RE: Atlantic Coast Pipeline - Review of June 1, 2017 Submittal in Response to Request for Information

Atlantic Coast Pipeline

DEQ Review Comments – Request for Additional Information

Dominion Atlantic Coast Pipeline Dye Tracing Recommendations

Figure 1. Valley Center-Dever Gap Karst (Q11)

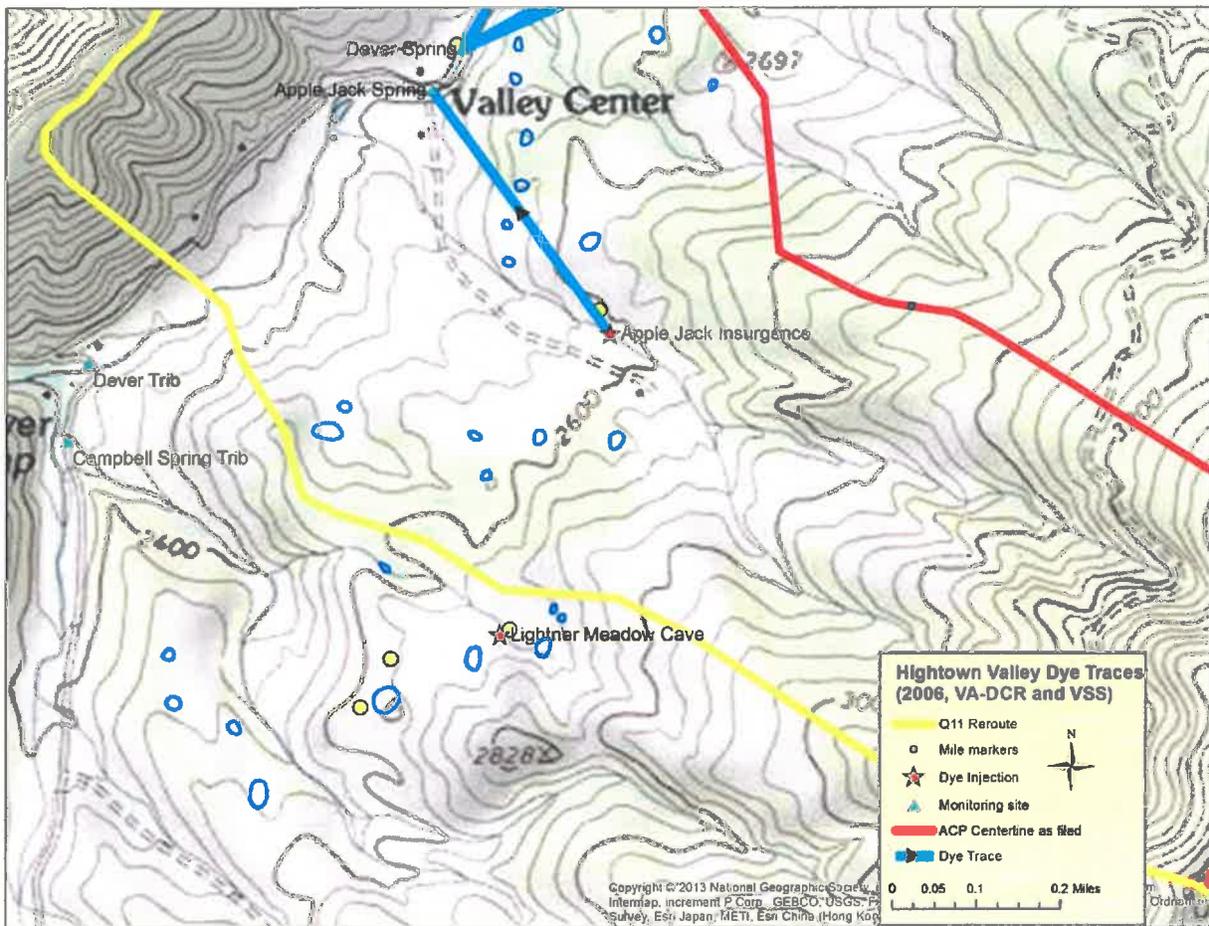
1) Hightown Valley – Additional dye tracing recommended

The Rev12 alignment has sufficient existing dye trace information based on dye trace studies performed by VA-DCR in conjunction with the Highland County Cave Survey in the early 2000s. Geoconcepts has the results of these traces. However, the karst along Rev12 near Valley Center was deemed so sensitive by Geoconcepts that an alternative route to the southwest, named Alternative Q11, is under consideration. While the Q11 reroute avoids an area of intense karst just east of Valley Center, it still crosses a belt of well developed karst that includes sinking streams, caves, and sinkholes. The Q11 alternative is shown in Figure 1. There are several features proximal to the Q11 alignment that are of concern, and their resurgences (i.e. springshed identity) should be determined for the purposes of emergency response. This would require 2 to 4 injections total along either side of the Q11 reroute. The Lightner Meadow Cave injection shown in Figure 1, if it ever occurred, was never recovered. Currently

we do not know whether Apple Jack Spring, Campbell Spring, or both receive drainage from the proposed alignment.

Figure 2. Little Mountain West Karst Area

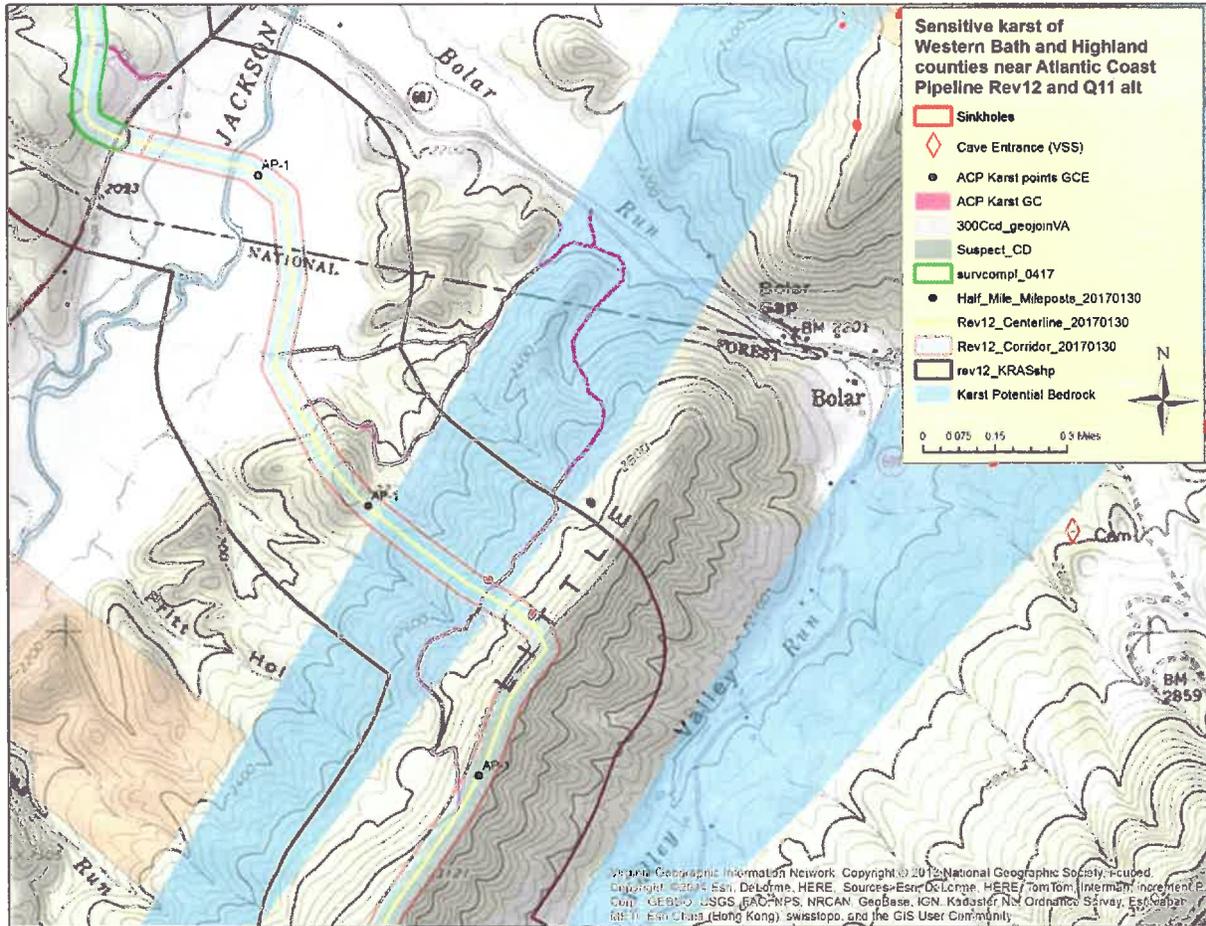
2) Little Mountain West – MP 92 – 92.3: Dye tracing may be needed.

No boots on ground yet. Hubbard has two sinks mapped here (see Figure 2.) If no sensitive karst features are identified by Geoconcepts, no dye tracing is recommended.

Figure 3. Little Valley Karst

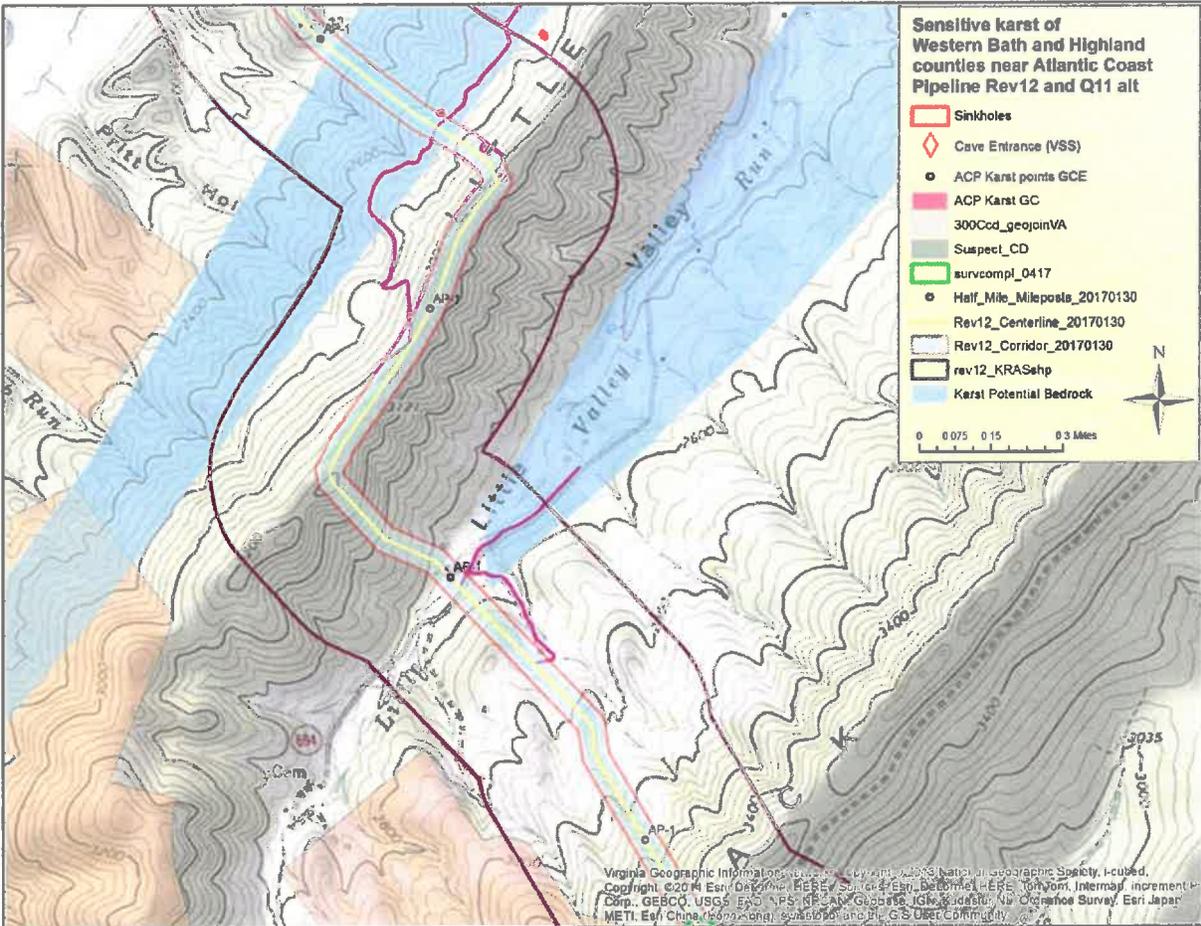
3) Little Valley/North side of Jack Mountain – Possible dye tracing

Property owner reports multiple small sinks within Rev12 corridor near valley floor at southwestern end of carbonate rock outcrop belt (see Figure 3.) Report corroborated by Geoconcepts Engineering field staff, which just received access to the property week of May 29. There is very low likelihood of significant caves, but potential exists for aquifer contamination resulting from release to a karst feature. While the massive limestone is more or less as shown in Figure 3, reconnaissance by VA-DCR on June 7 suggests significant karst hydrological development within limestone bearing portions of the strata west and south of the area depicted as limestone in Figure 3. It is likely that aquifers within these limestone are for the most part isolated from the deeper limestone exposed in the core of the valley to the northeast.

Figure 4. Burnsville Cove Karst Hydro, ACP vicinity

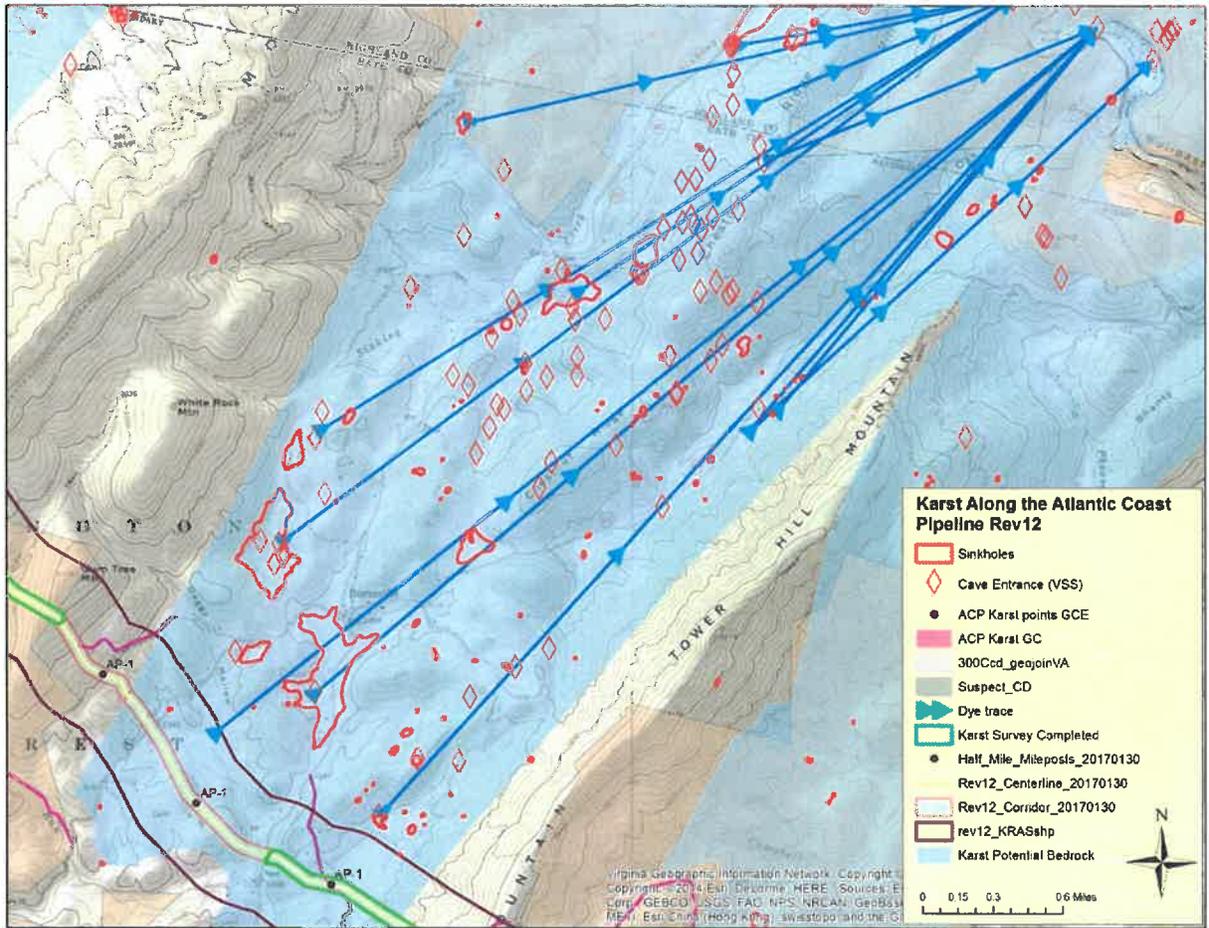
4) Burnsville divide – Dye tracing may be needed pending karst survey

The Rev12 corridor nicks the headwaters of the Chestnut Ridge Cave System (Aqua Spring Recharge Area) as well as a portion of the Cathedral Spring Recharge Area. Both springs lie about 5 miles northeast of the corridor in the Bullpasture River gorge (see Figure 4.) The existing dye trace information was used to delineate the Burnsville Cove Conservation Site, a globally significant conservation site associated with rare cave invertebrate species as well as several federally endangered bat species. If high risk features are identified by Geoconcepts Engineering during their karst surveys once property access is resolved, then those features should be dye traced unless they lie clearly within a well-delineated spring basin.

Figure 5. Fort Lewis Karst

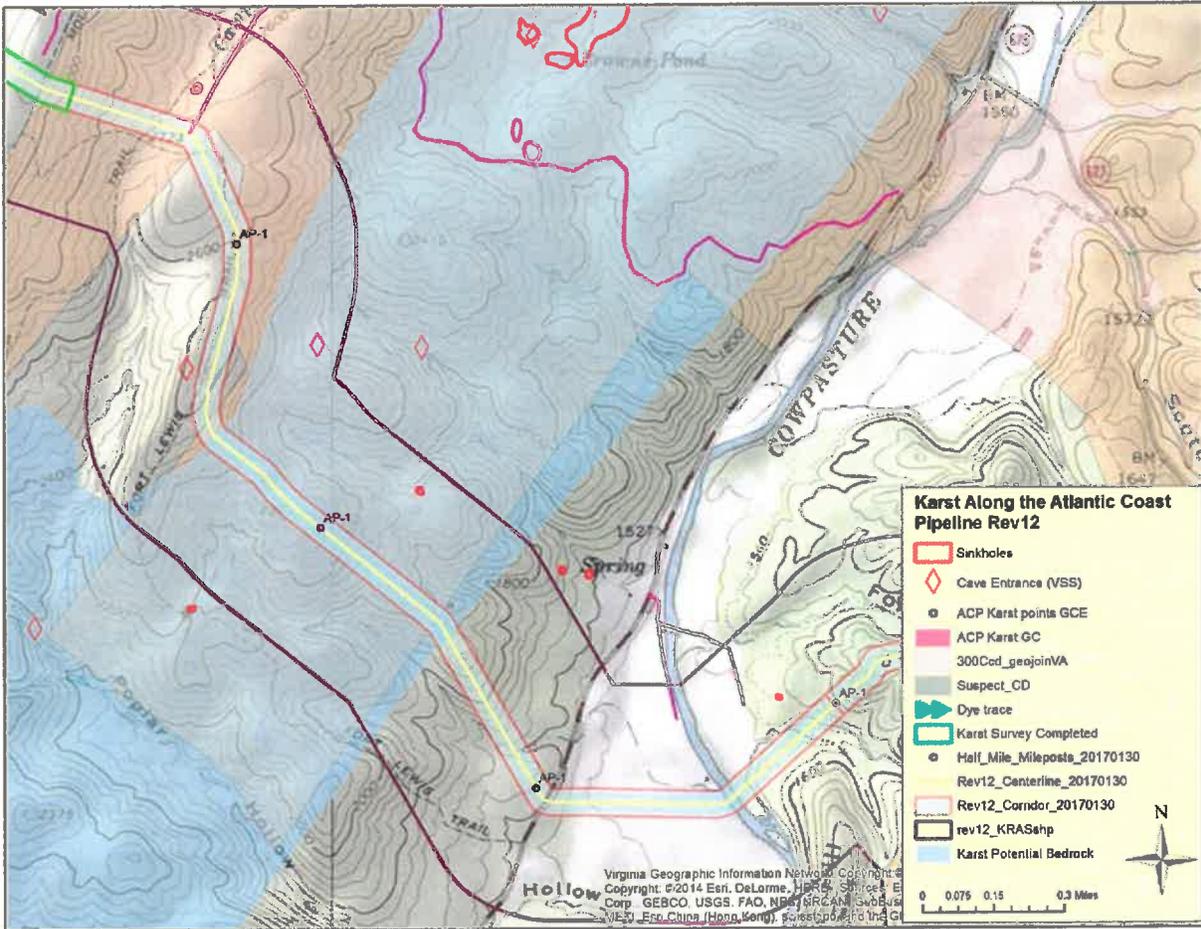
5) Fort Lewis Karst (south side of Tower Hill Mountain) – Dye traces likely needed pending karst survey

Geoconcepts Engineering has not yet had access to this property. Reconnaissance by VA-DCR showed sinkholes present in the vicinity of the Fort Lewis trail and along the southeastern slope of Tower Hill Mountain, and there is one small cave (Jewell Box Cave) along the ridge within 100 – 200 ' of the corridor (see Figure 5.) Please note that karst features extend beyond the boundary of “Karst Potential Bedrock” as depicted in Figure 5. Any sinkholes identified as high or medium risk once property has been surveyed by Geoconcepts staff should be delineated to determine the resurgences. A spring at the base of Tower Hill Mountain along the Cowpasture is the likely destination for any water entering karst features in this section of the pipeline, but dye trace studies should verify this.

Figure 6. Karst along Brush Ridge and Walker Mountain, vicinity of ACP

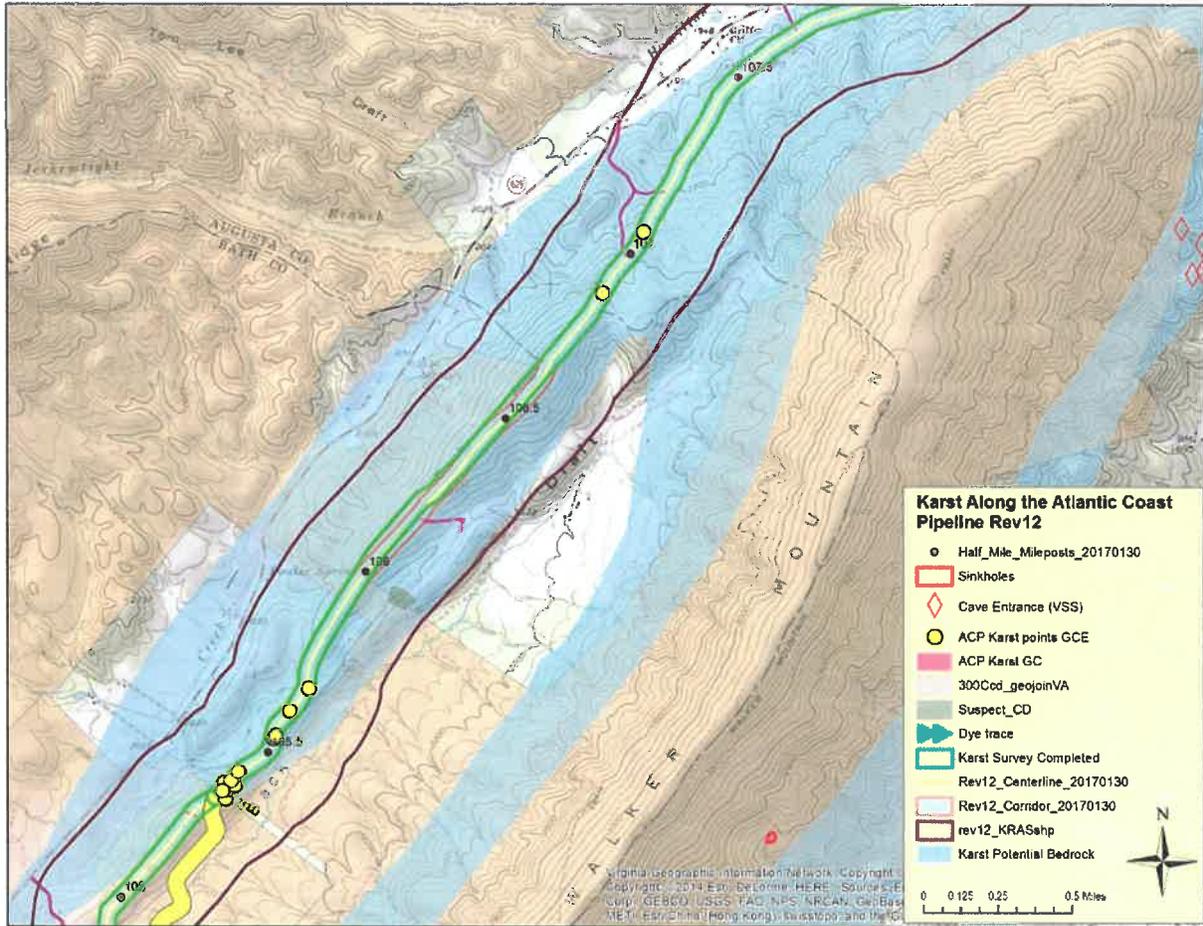
6) Brushy Ridge/Walker Mountain, ~ 105.5 – 109 – Dye trace any high risk features.

This bumps up against Deerfield Spring trace (item 7.) From 105.2 to 105.8 are numerous documented karst features (see Figure 6.) 4 of the features in this stretch are documented as high risk, while 7 are documented as moderate risk by Geoconcepts staff.

Figure 7. Karst Hydro Setting of Deerfield Spring

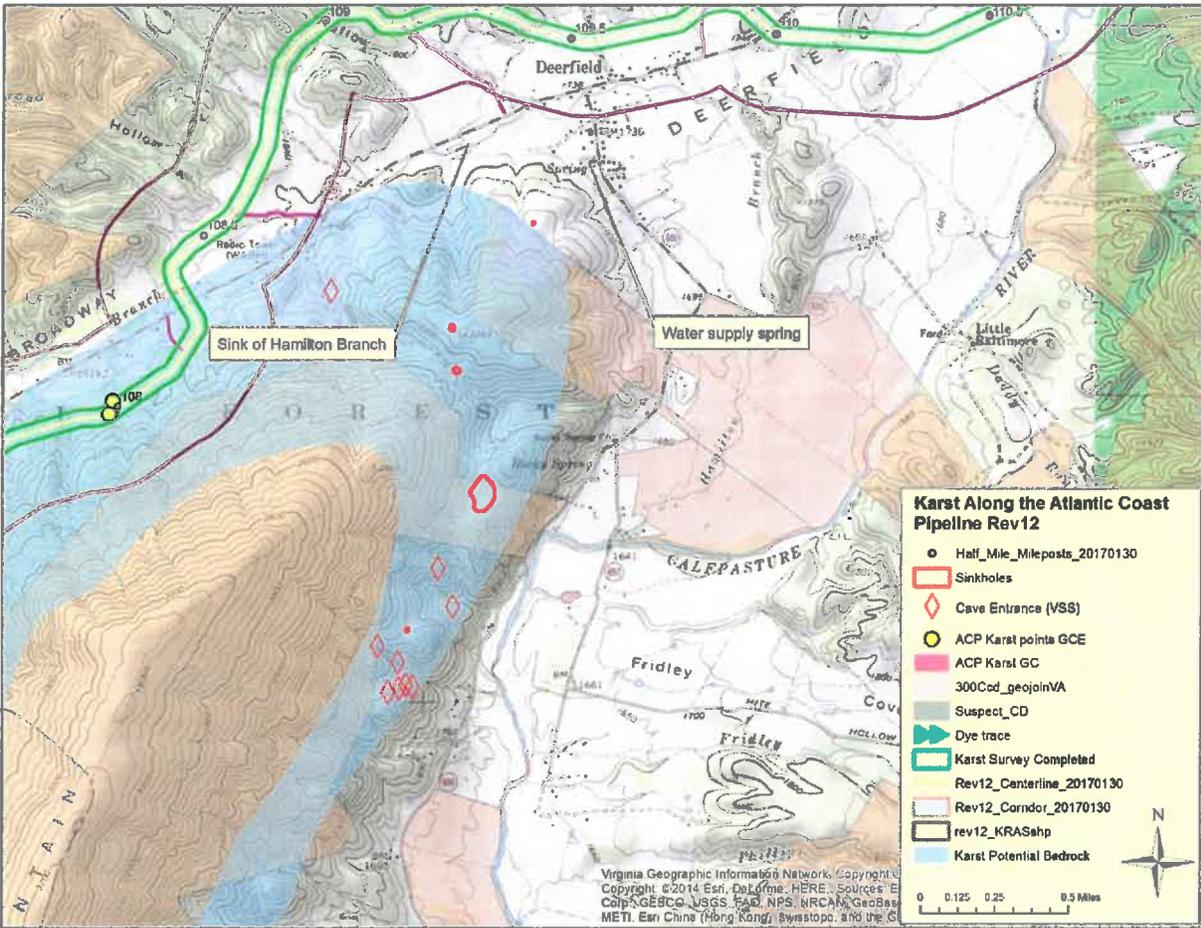
7) Deerfield Spring trace.

Preliminary evidence suggests that the Deerfield Spring, a public water supply, receives a significant percentage of its flow from Hamilton Branch, which sinks into limestone underlying alluvial deposits just west of the spring (see Figure 7.) This connection should be confirmed, and if proven may indicate that proposed layout yard near Deerfield needs to be relocated.

Investigations in this area should be performed in coordination with Joel Maynard of the Virginia Department of Environmental Quality.

Figure 8. Shenandoah Valley Karst and ACP

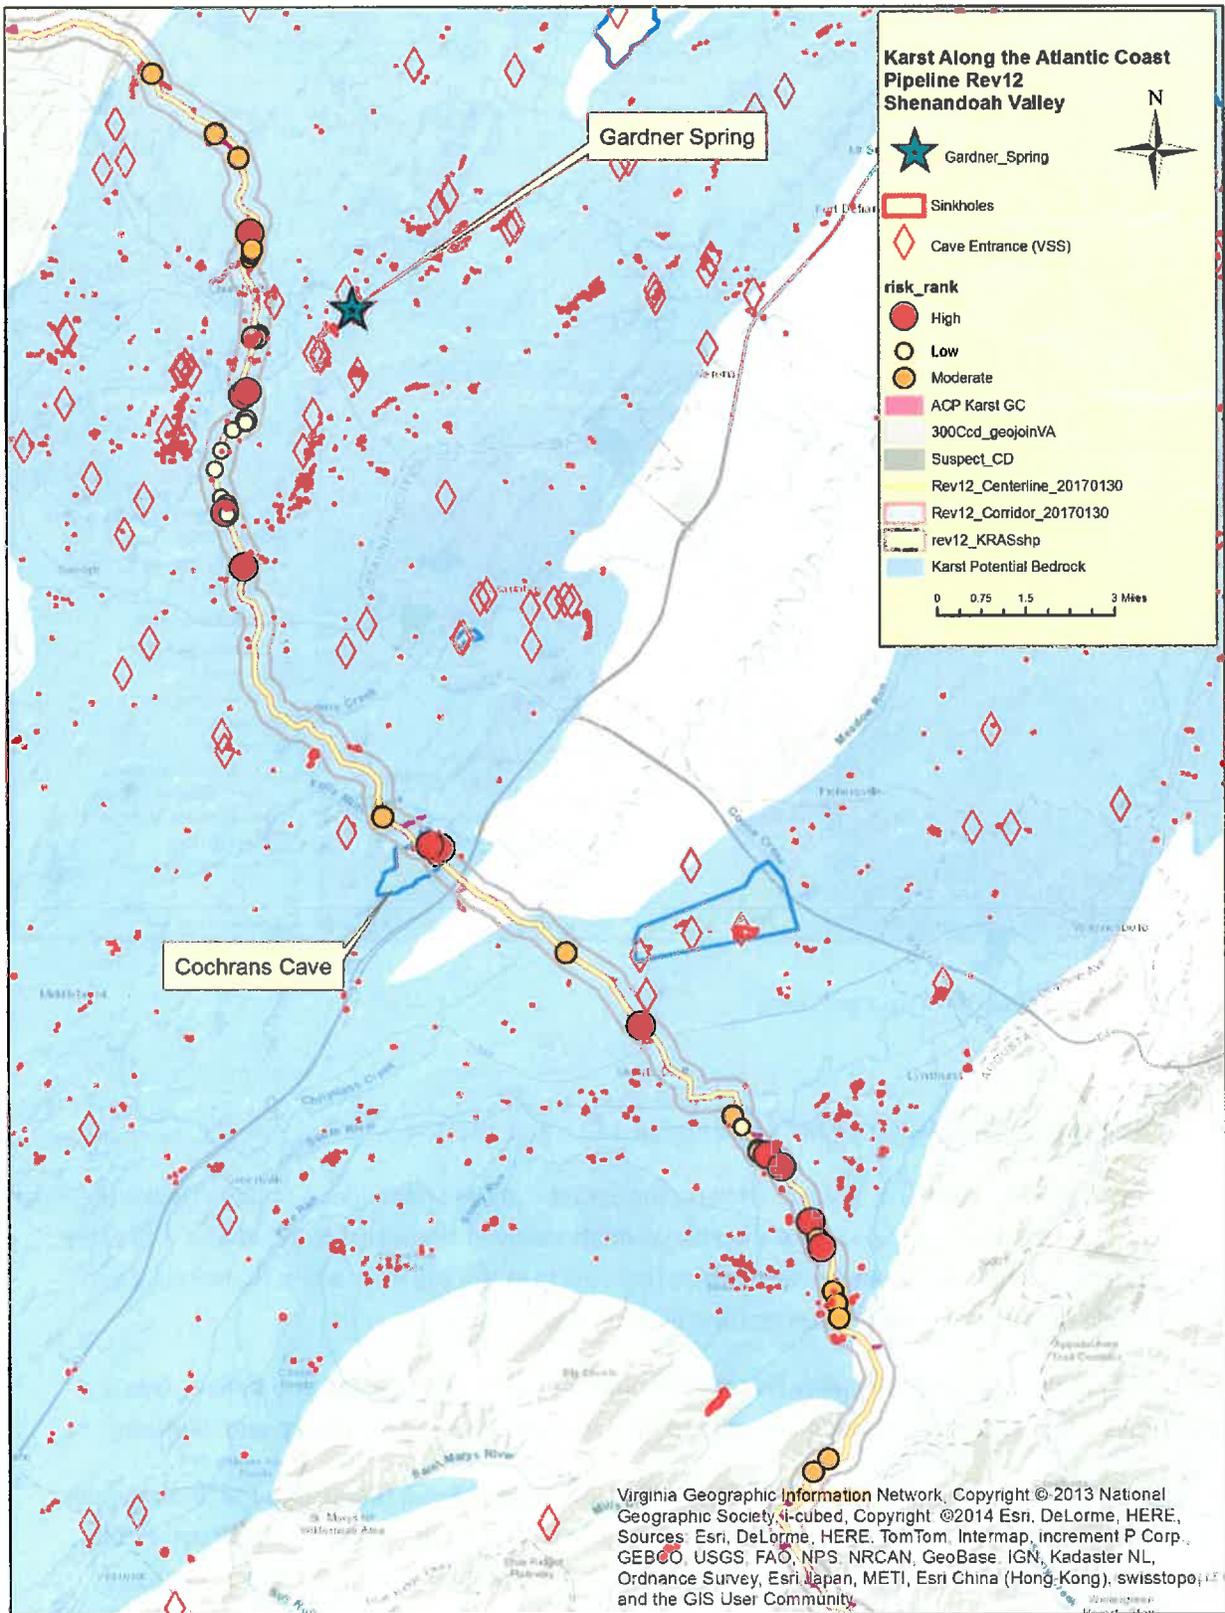
Geoconcepts has identified 15 high-risk features and 24 moderate-risk features in the Shenandoah Valley Section, and overview of which is shown in Figure 8. Five of the high-risk and seven of the moderate-risk features have been address by the work performed to date in the Cochran's Cave Conservation site.
